[RE-BID](#) ADDENDUM NO. 01

JOHNSON CITY CENTRAL SCHOOL DISTRICT

JCCSD CAPITAL PROJECT PHASE 2

HA PN 2024-239P

DRAWING TITLE:
SECOND FLOOR ROOM 222 & ROOM 233D IT RENOVATION PLANS
DRAWN BY: S.G. PROJECT NO.: 2024-239P
CHECKED BY: X.X. BUILDING DRAWING NO.: HS A-112
DATE: 12-01-2025

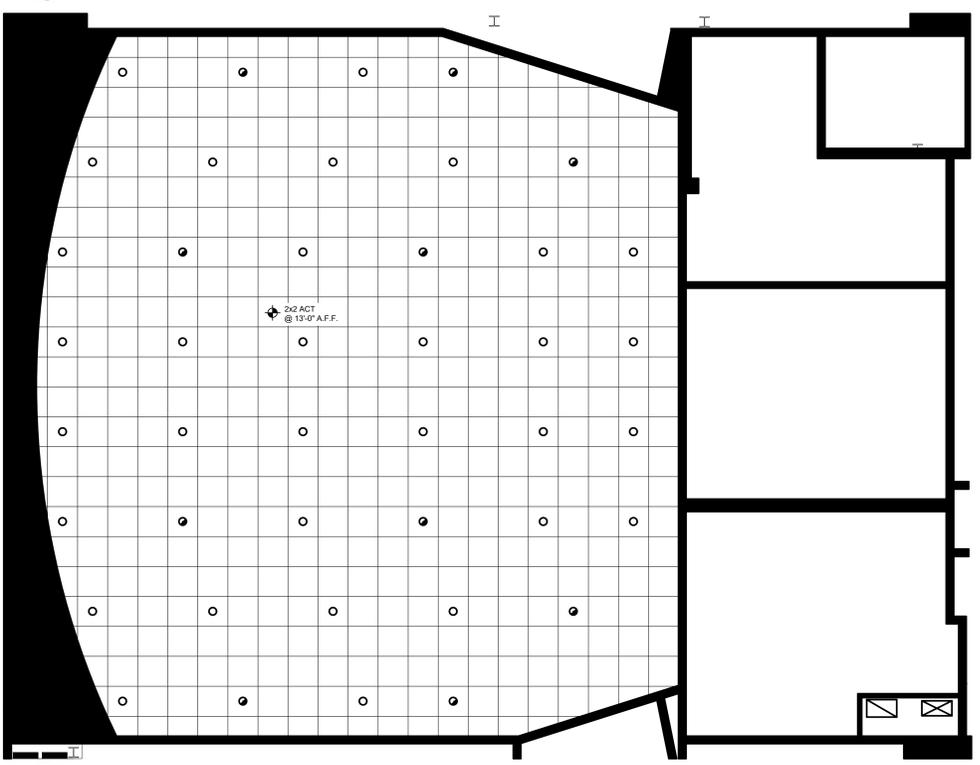
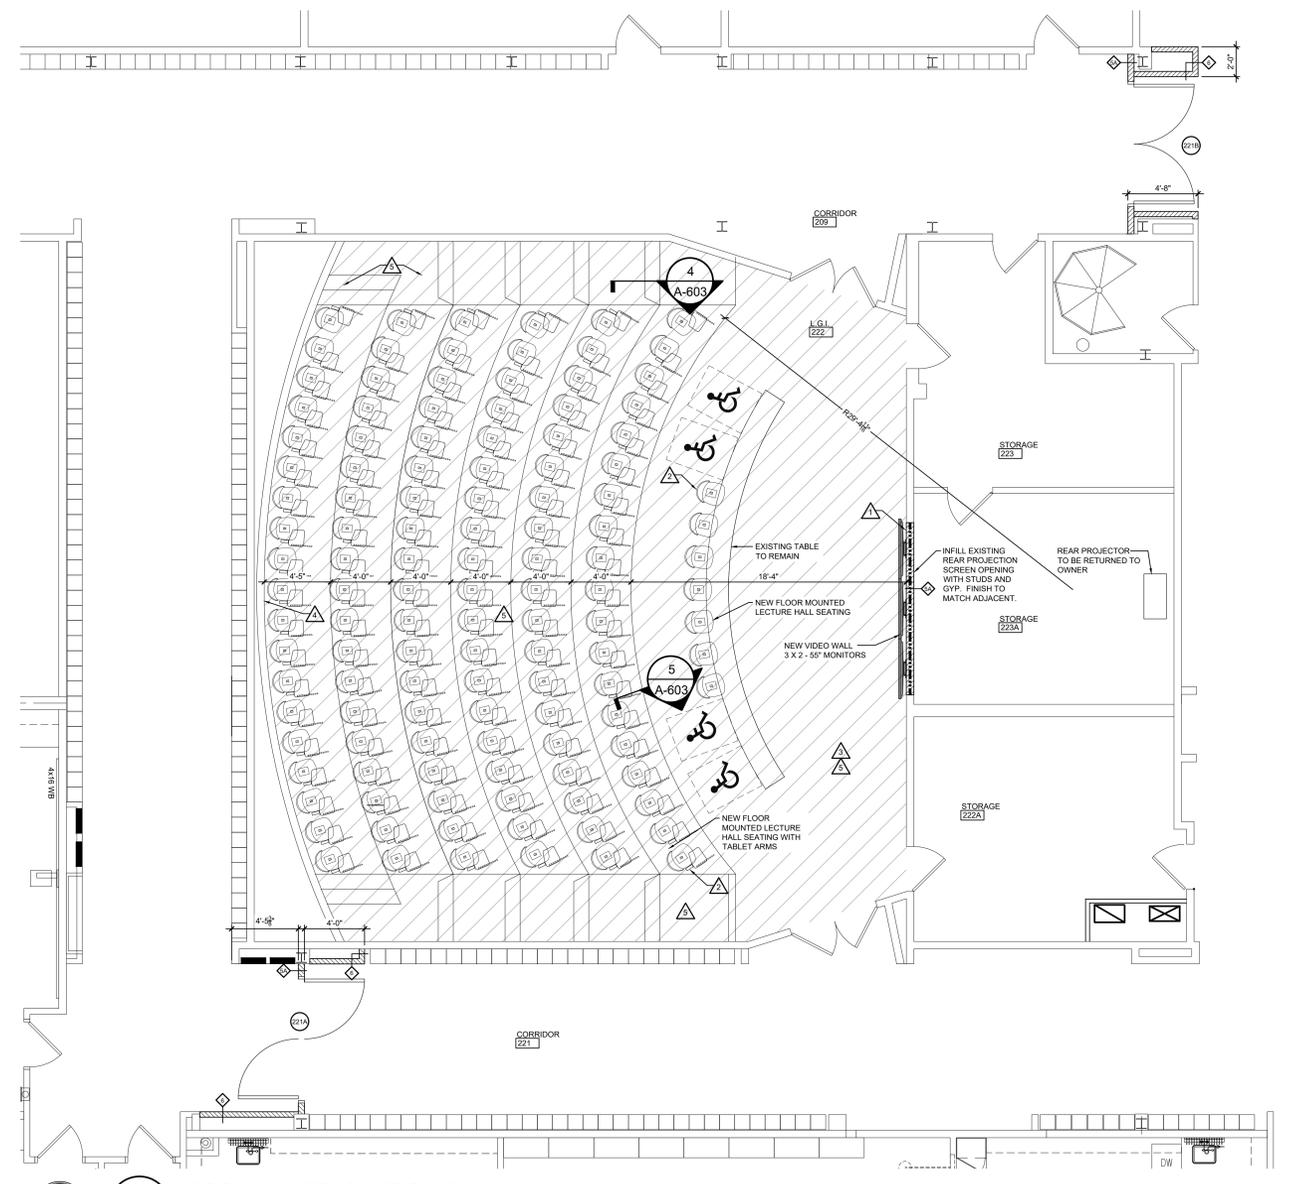
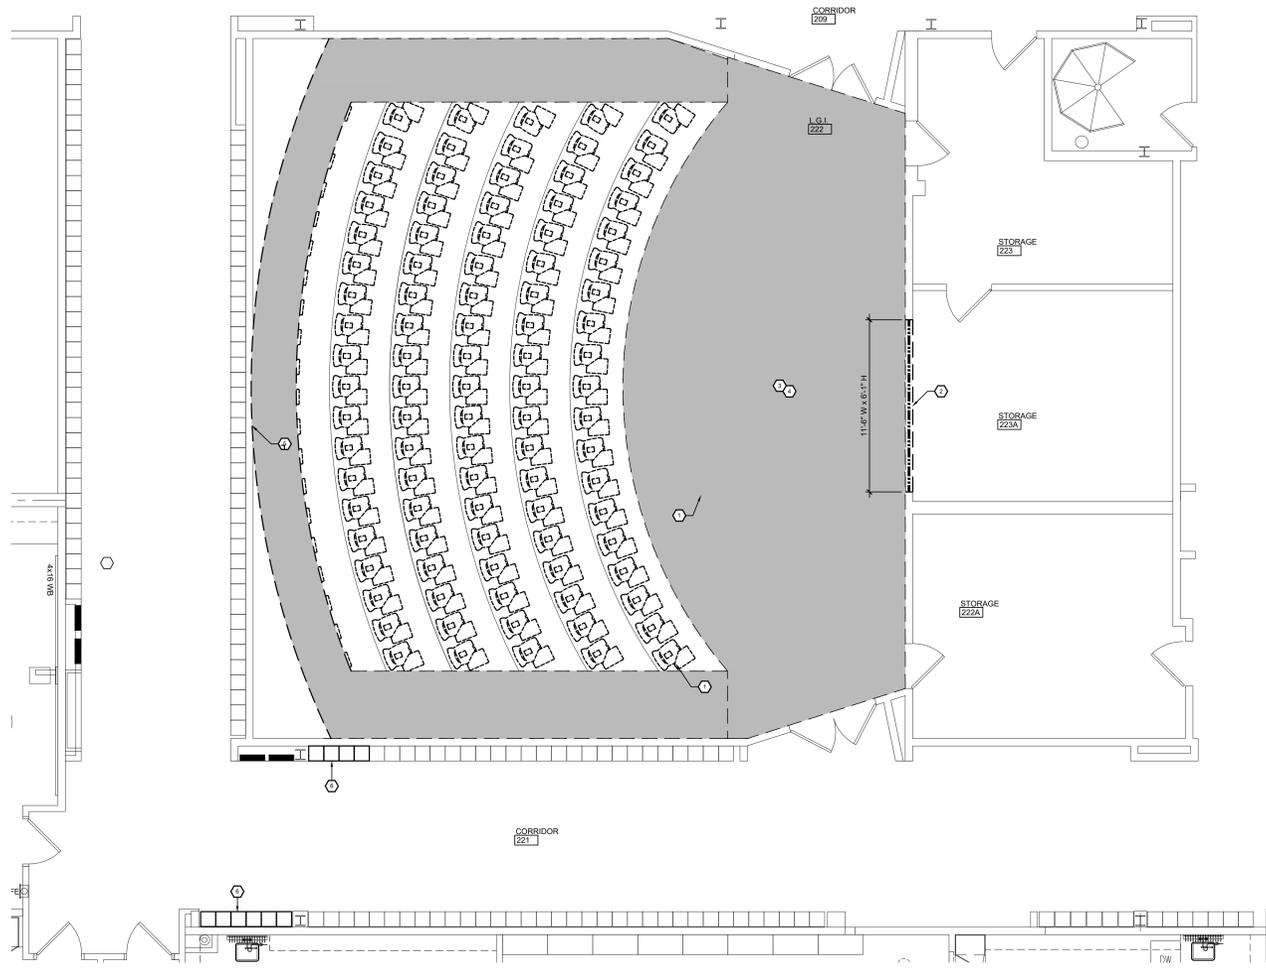
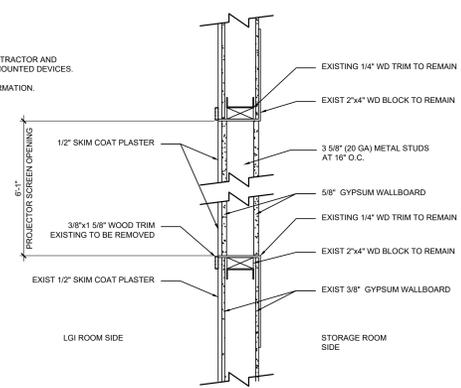
REVISIONS
RE-BID ADDENDUM #1 02/16/26
UPDATED DEMO KEY NOTE #4
UPDATED CONSTRUCTION KEY NOTE #2

**DESIRED FIXED LECTURN SEATING SHALL BE HUSSEY SEATING.
SEE UPDATED DRAWINGS HS-A-112 & HS-A-600 ATTACHED.**

DRAWING TITLE:
DOOR SCHEDULE AND DETAILS

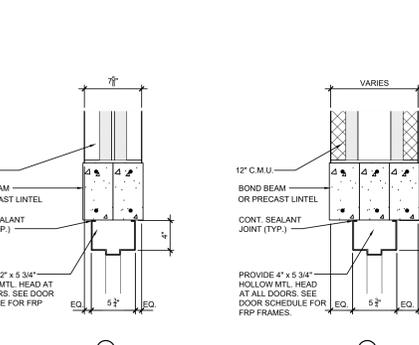
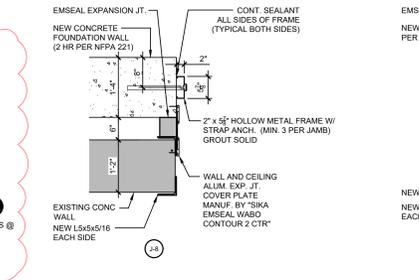
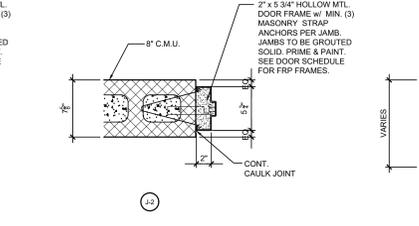
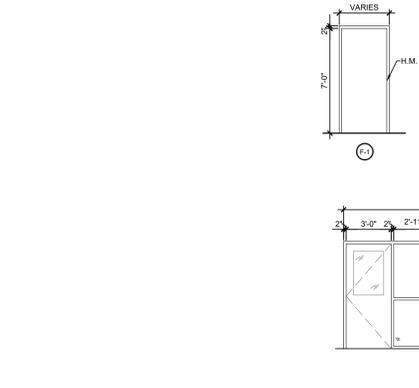
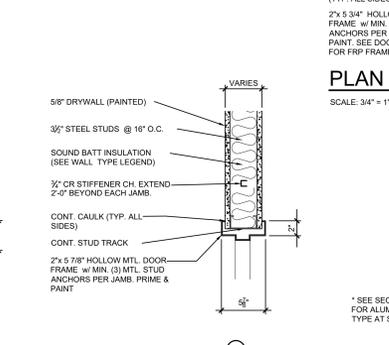
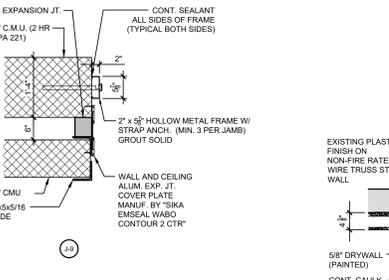
Request: Is Door 141 Type C Wood with HM Frame Type 5 per Drawing A-400 or Fire Aluminum Type D Per Note on A-500?

- Request:**
1. Doors 125B, 139A and 146B call for TSG but they also have a 45 Minute Rating on them. Please advise what glass type these need to be.
 2. Conference Room 138E Door calls for Fire Rated Glazing, but Storefront frame (BL-4) next to it calls for 1/4" Tempered Glass, Please advise what glass type the door and storefront frame need to be.
 3. Doors 141C and 141D call for TSG, all other glazing openings in the Main office call for Fire Rated. Please advise what glass types need to be in 141C and 141D.

ANSWER: DOOR 141 IS A 45 MINUTE FIRE RATED ALUMINUM DOOR SYSTEM WITH 1 HOUR FIRE RATED ALUMINUM FRAME SYSTEM WITH 1 HOUR FIRE RATED SIDELITES. DOOR 141 ON THE DOOR SCHEDULE DRAWING A-400 IS TO BE REVISED.

1. FRSG IS REQUIRED FOR 45 MINUTE FIRE RATED DOORS 125B AND 146B. DOOR 139A SHOULD NOT BE A FIRE RATED DOOR, DELETE FIRE RATING FOR THIS DOOR FROM THE DOOR SCHEDULE.

2. DELETE FIRE RATING FROM DOOR 138E.

3. DOOR 138A AT STORAGE RM 138C IS A 45 MINUTE FIRE RATED DOOR. DOORS 138, 138E, 138F, 140, 140A, 140B SHOULD NOT BE A FIRE RATED DOOR, DELETE FIRE RATING FOR THESE DOORS FROM THE DOOR SCHEDULE.

ALSO, BL-3 ADJACENT TO PASSAGEWAY 138H AT SMALL CONF. ROOM 138F IS NOT FIRE RATED AND SHOULD BE TEMPERED SAFETY GLASS IN NON RATED ALUMINUM STOREFRONT SYSTEM SIM AS NOTED FOR BL-4.

DRAWING TITLE:
 SECOND FLOOR CONSTRUCTION FRAMING PLAN

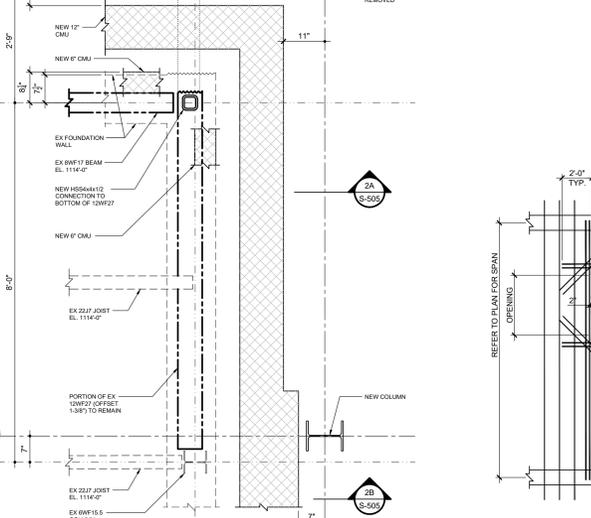
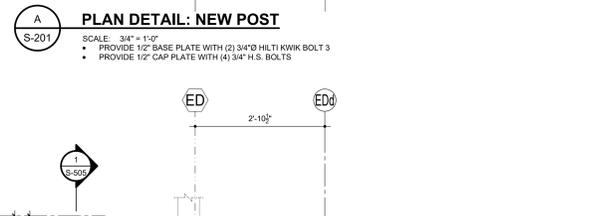
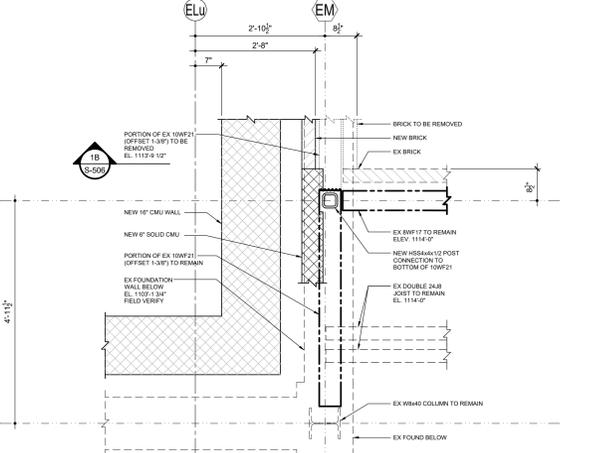
- REVISIONS**
- 01/06/26
 - BID ADDENDUM #7
 - INDICATED TANK AND REFERENCED TO SCORING AREA SLAB
 - ADDED ELEVATION TO SCORING AREA SLAB
 - ADDED ELEVATION TO EXTERIOR CONCRETE PADS ON EXTERIOR
 - CONCRETE PADS START TO ARCH DWGS
 - REBID ADDENDUM #1
 - 02/16/26
 - ADDED NOTE
